Subject: Oyster Creek Nuclear Generating Station (OCNGS)  
Operating License No. DPR-16  
Docket No. 50-219  
Response To Additional Information  
Concerning In-Structure Response Spectra

GPU NUCLEAR RESPONSES TO ADDITIONAL INFORMATION

REQUESTED BY NRC LETTER DATED

REGARDING IN-STRUCTURE RESPONSE SPECTRA

Figure 1s1-1: Deconvolved Motion, 3 Soil Conditions vs. 60% of Ground Surface Target, OCNCS Reactor Building

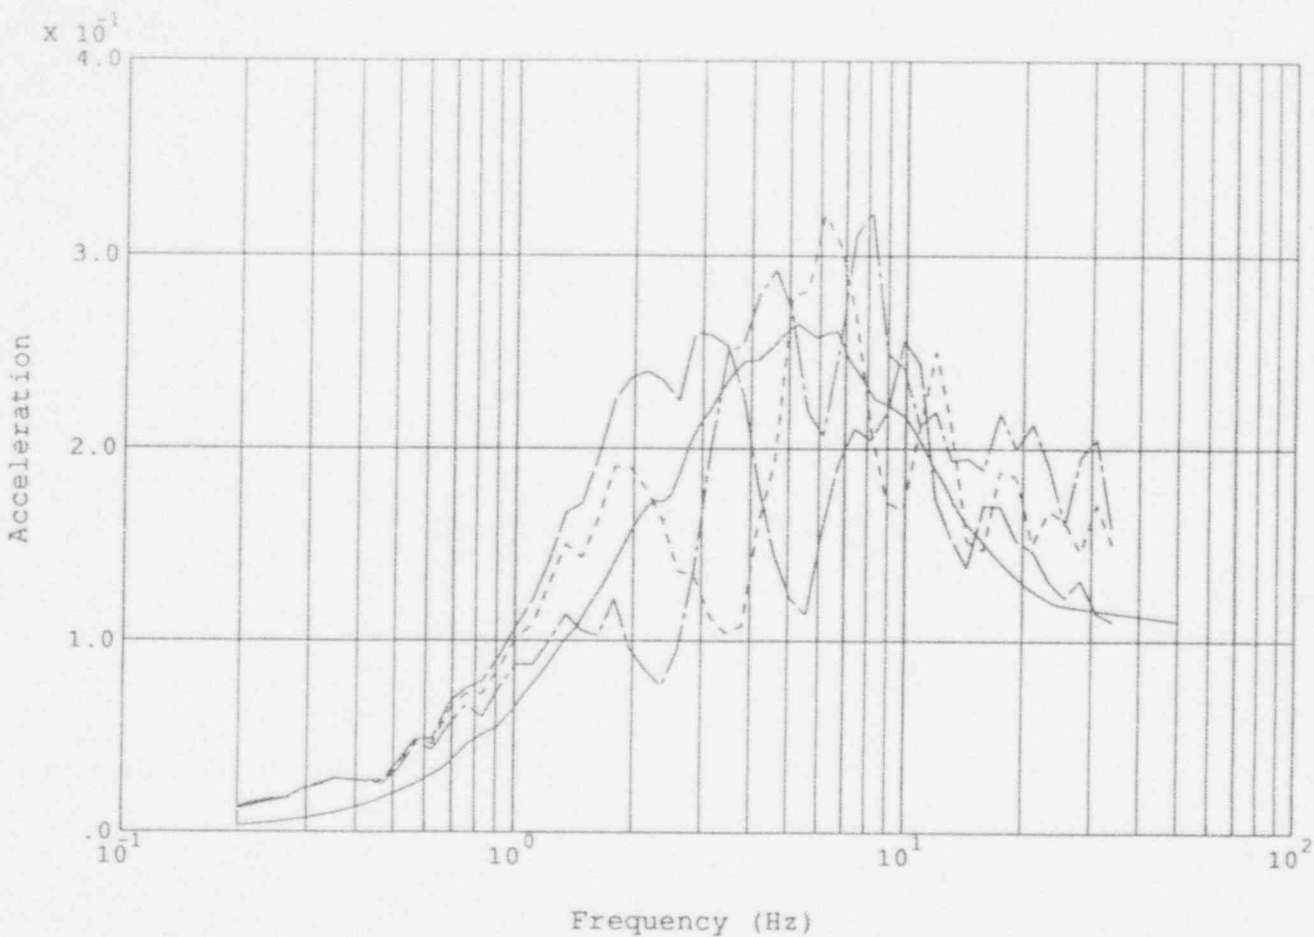
Provide the three sets of spectra (corresponding to the three high-strain soil profiles) developed at the foundation level together with the enveloping spectra and 60% of the site specific response spectra (SSRS). Also, provide modified synthetic time-histories (if any) developed to ensure that the 60% criterion is satisfied.

1. The deconvolved spectra for the two horizontal time histories developed at the foundation level for the three high strain soil profiles and the time histories to be used in the final analyses are shown in Figures 1s1-1 and 1s1-2. The envelope of the three spectra for each of the horizontal directions are shown in Figures 1-1 and 1-2. These figures show the comparison of both horizontal components to 60% of the surface spectrum. The spectra from these time histories meet the 60% requirement at all frequencies. These time histories are included in the diskette as part of the response to Question 4.

## STAR TRUSS

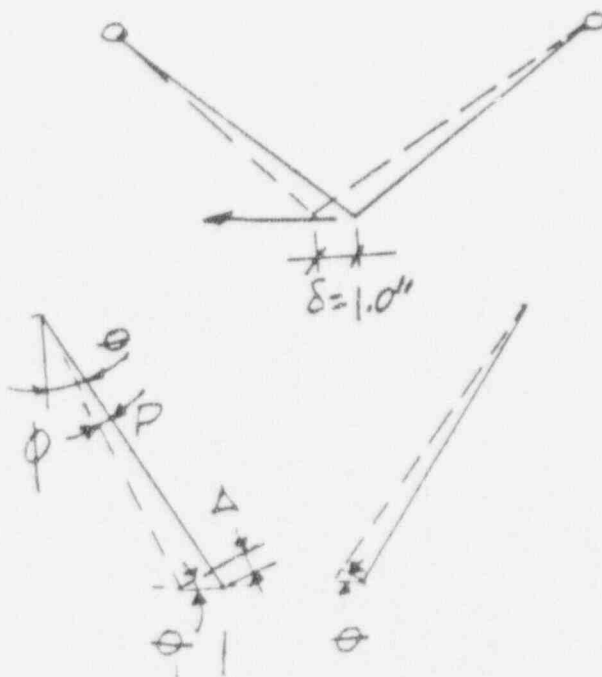
1. ERROR IN AREA OF LEGS
2. QUESTION ON LOCAL RADIAL STIFFNESS OF DRYWELL VESSEL

THIS INDICATES THAT WITHOUT RADIAL RESTRAINT PROVIDED BY DRYWELL, THE INTERFACE STIFFNESS CANNOT BE DEVELOPED BY TRUSS MEMBERS NOT ORIENTED SO THAT COMPONENTS OF FORCES IN LEGS WILL CANCEL OUT NORMAL TO SHELL

THIS IS ABOUT  $\frac{1}{3}$  THAT CALCULATED

IN REALITY, THE SPRING CONSTANT OF THE STAR TRUSS IS IN BETWEEN BLUME'S VALUE (690,081 KIPS/FT) AND GH'S VALUE (222,360 KIPS/FT). CONSIDERING THAT THE USE OF A LOWER SPRING CONSTANT WILL TEND TO LOWER THE CALCULATED NATURAL FREQUENCY OF

DRYWELL, GH'S APPROACH IS CONSERVATIVE.

THEREFORE, GH'S APPROACH TO EVALUATE THE RIGIDITY OF THE STAR TRUSS IS CONSERVATIVE.

S-1) DISCRPTIONS

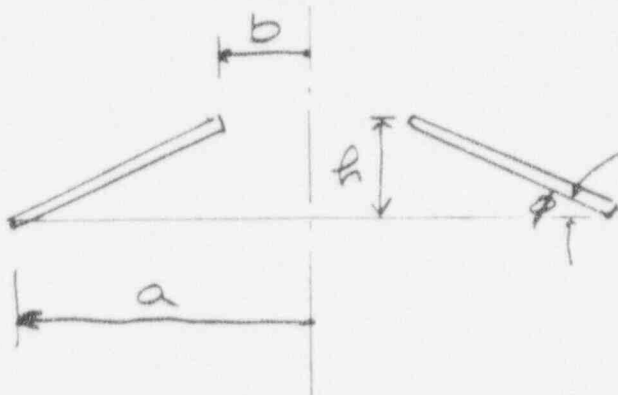
URS/BLUME PROVIDE NO SUPPORT FOR USING THE 48,000 KIPS/FT SPRING VALUE IN THE CALCULATION.

THIS SECTION OF THIS VERIFICATION IS TO DETERMINE IF THE USE OF 48,000 KIPS/FT BY BLUME AND ACCEPTED BY G14. IS REASONABLE.

$$\therefore K = 53,000 \text{ KIPS/FT} \sim 48,000 \text{ KIPS/FT}$$

53,000 KIPS/FT IS VERY CLOSE TO 48,000 KIPS/FT THAT URS/BLUMING USED.

THEREFORE, USE OF 48,000 KIPS/FT FOR  
Rx STABILIZER SPRING CONSTANT IS REASONABLE.

FIG. 2s1-1

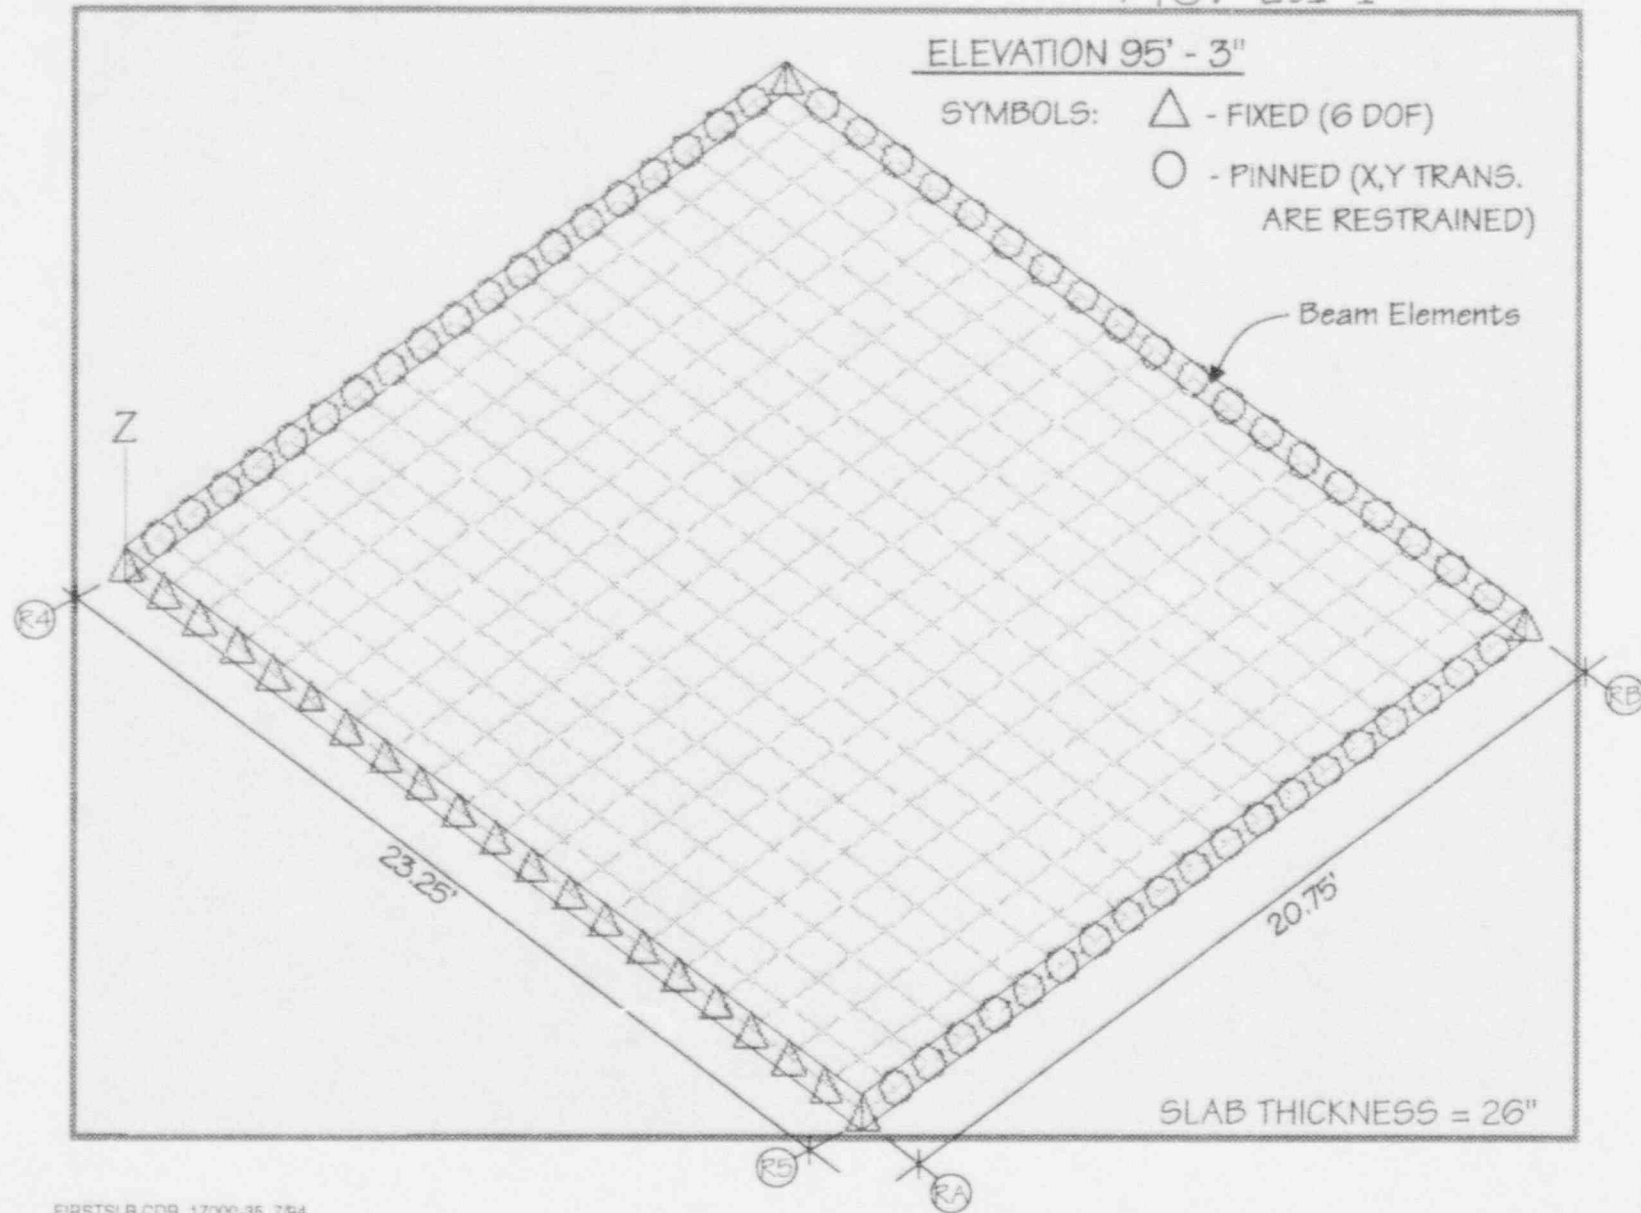
- 2.c A number of floor slabs and walls at OCNGS have been identified as vertically flexible. Provide information related to the plans for developing vertical floor response spectra for these floors.

The first slab selected is at elevation 95'-3" between column lines RA, RB, R4, and R5. Its plan dimensions are 23.25' by 20.75' and its thickness is 26". At line RA, the slab is connected to a wall and is supported by beams at the other lines and by columns at the corners. The modal analysis of this slab predicts a fundamental vertical frequency of 43.5 Hz.
